Land Use Resource Consent Conditions – Assessment of Application Update 31-03-2023

SR500876 – 1 Tasman St, Mt Cook

Proposed LU Consent Conditions & Advice Notes – Updated 31-03-2023 (read in conjunction with tracked set).

Level 00 – Ground Floor

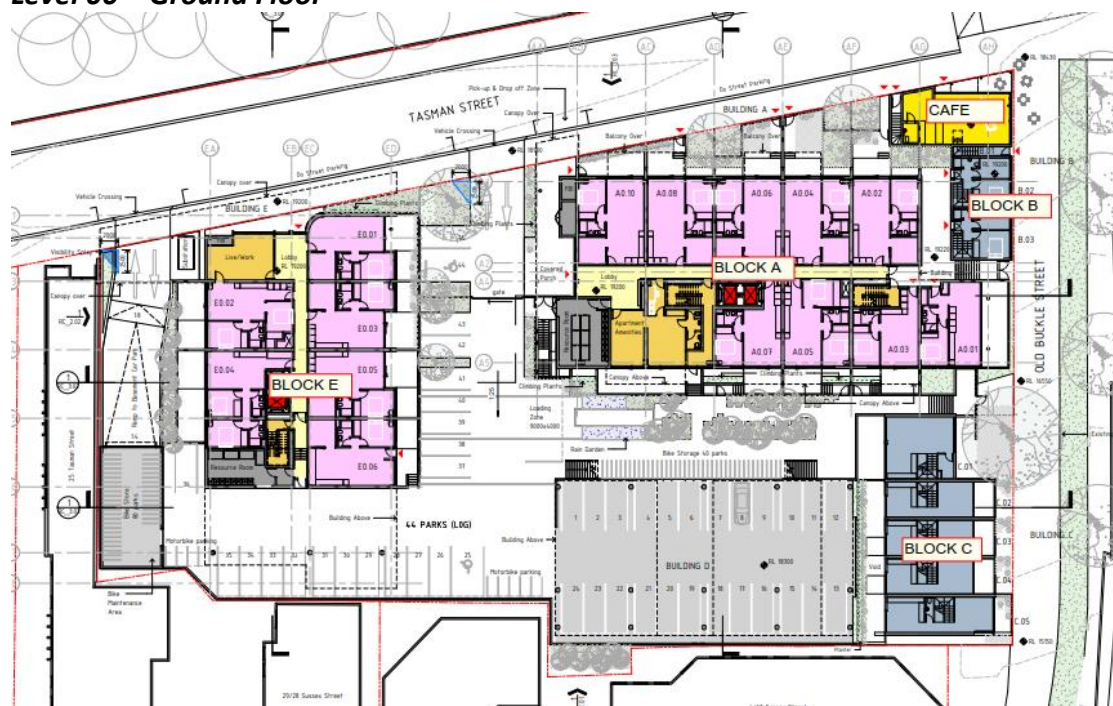
- Northern Apartment Block – Building A
- Southern Apartment Block – Building E
- Café at the corner of Old Buckle St and 1 Tasman St.
- Townhouses
 - 5 townhouses (Block C) front Old Buckle Street and have basement levels below the road reserve – with access to the car parking basement to the rear of the units).
 - 8 townhouses (Block D) are internal to the site and elevated at first floor level above the ground floor car parking
 - 2 townhouses (Block B, Units B01 and B04) at the corner of Old Buckle St and Tasman St. These townhouses are located above the new café.
 - townhouses (Block B, Units B02 and B03) at the corner of Old Buckle St and Tasman Street.

Basement Level Car Park & Block C Townhouses with Block A and D outlines

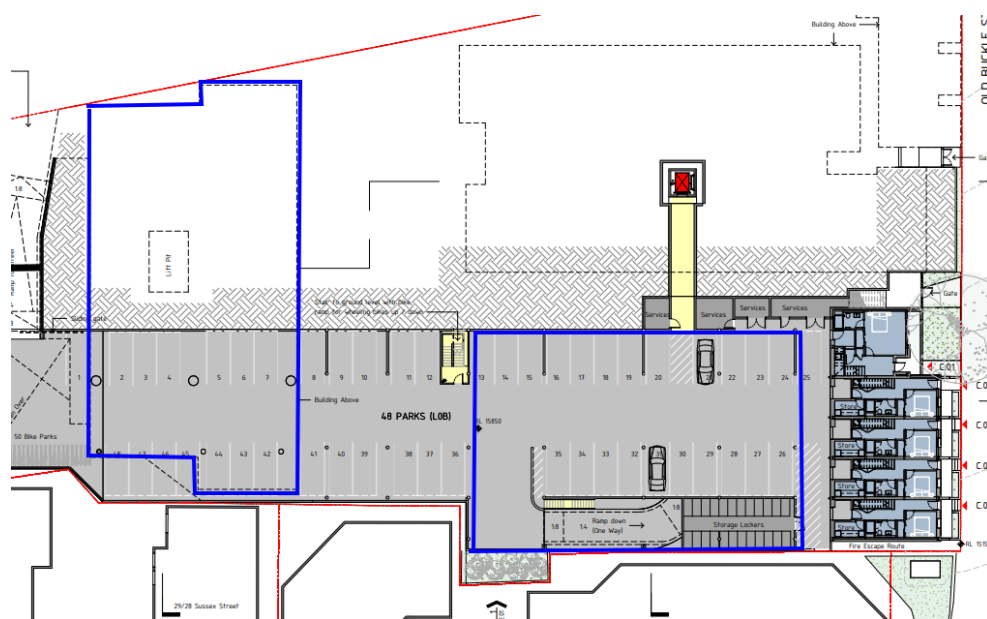
The site includes a basement car park located below Block E, Block D and to the rear of Block C. As above the Block C townhouses have a basement level and an access to the basement level car park. The basement is typically smaller on the March 2023 plan set with the lockers removed, however an additional link have been provided to Block A and additional servicing rooms provided between the basement and block A. These will significantly restrict servicing options between Block A and D – the servicing within this area will be private and it will be the applicant’s responsibility to ensure sufficient space for the servicing.
